Flood Control Project Maintenance
Levee Inspections

Spring 2017 Levee Inspection Results

Sutter Maintenance Yard Maintenance Area 0017

Waterway	Bank	Unit Miles
Unit No. 01 Lake County Sutter Maintenance Yard - Middle Creek	Left	3.87

Photo 1 of 1 : SP_2017_MA0017_339_15_20170315_00003.jpg

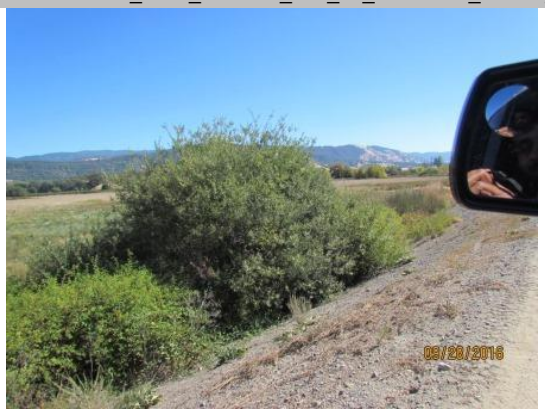
V2 : Remove the wild growth other than native grasses from the levee slopes.

Large bushes and brambles covering wire fence, limiting visibility and access.

View of the large bushes limiting visibility and access.

Photo 1 of 1 : SP_2017_MA0017_339_16_20170315_00004.jpg

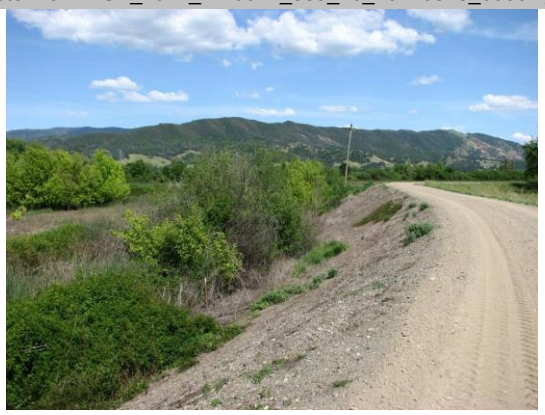
V2 : Remove the wild growth other than native grasses from the levee slopes.

Large bushes and brambles growing on wire fence on LS toe limiting visibility and access.

5/2/2016: Remove or trim dense vegetation growing on fence to allow visibility and access to L/S toe.

Photo 1 of 2 : UCIP_SP_2017_50818_46860.jpg

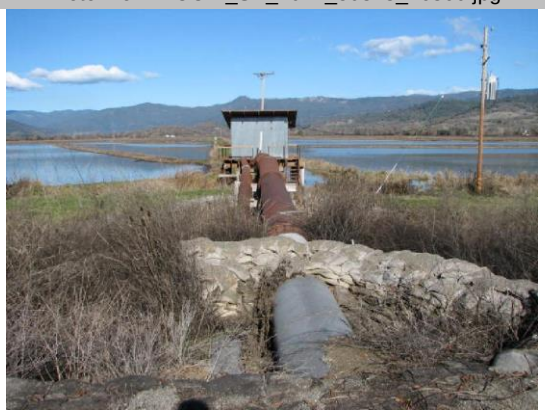
FS_ID:50818
DS_ID:847
EP_NO: 11469
Repair Type: Non-Urgent
Crossing Status: Found
UCIP Comments: 10/19/2016 Sack ring still in place. (DWR Sutter Yard- AFreitag)6/14/2016 Sack ring is still built up underneath the pipes.4/23/2015 Sack ring is still built up underneath the pipes.7/3/2014 Same as last inspection.12/23/2013 Same as last inspection.8/2/2013 Same as last inspection.12/13/2012 flood fight materials-ring levees around both LS and WS slopes at pipe crossing. This may or may not be an issue.
FIELD_STRUCT_DESC: 1 of 2: 16-inch steel drainage pipe through the levee, 5 feet below the crown. Drainage pumping plant on the landside (LS). Flap gate on the waterside (WS) end. (Automatic Board Order (ABO) issued as Permit No. 11469, 1975 - RD 2070). [Additional Reference(s): DWR Levee Log, 2005. USACE Sacramento O&M Manual 506.3, August 1961, (HLM 5.43)].
FS Date: 11/21/2016 12:11:57 PM

Pumping plant, pipes, and ring levees on LS toe.

Photo 1 of 2 : UCIP_SP_2017_50819_46864.jpg

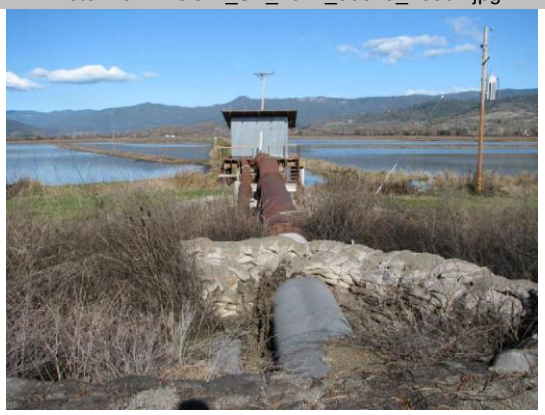
FS_ID:50819
DS_ID:853
EP_NO: 11469
Repair Type: Non-Urgent
Crossing Status: Found
UCIP Comments: 10/19/2016 Sack ring still in place. (DWR Sutter Yard- AFreitag)6/14/2016 Sack ring is still built up underneath the pipes.4/23/2015 Sack ring still built up underneath the pipes.7/3/2014 Same as last inspection.12/23/2013 Same as last inspection.8/2/2013 Same as last inspection.12/13/2012 flood fight materials-ring levees around both LS and WS slopes at pipe crossing. This may or may not be an issue.
FIELD_STRUCT_DESC: 2 of 2: 36-inch steel drainage pipe through the levee, 5 feet below the crown. Flap gate and air vent on the waterside (WS) slope. (Automatic Board Order (ABO) issued as Permit No. 11469, 1975 - RD 2070). [Additional Reference(s): DWR Levee Log, 2005. USACE Sacramento O&M Manual 506.3, August 1961, (HLM 5.43)].
FS Date: 11/21/2016 12:12:31 PM

Pipes and pump house on LS toe with ring levees.

Photo 2 of 2 : UCIP_SP_2017_50819_46863.jpg

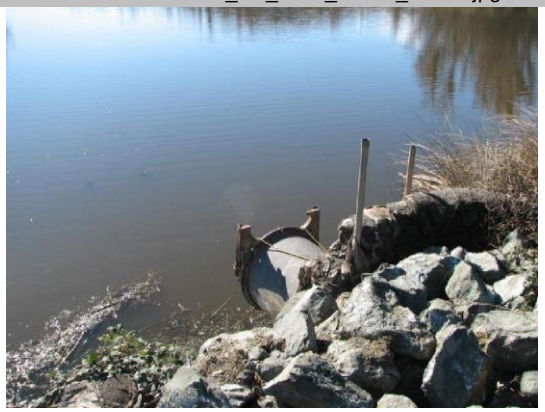
Pipe, flap gate, air vent, and sandbags on WS slope.
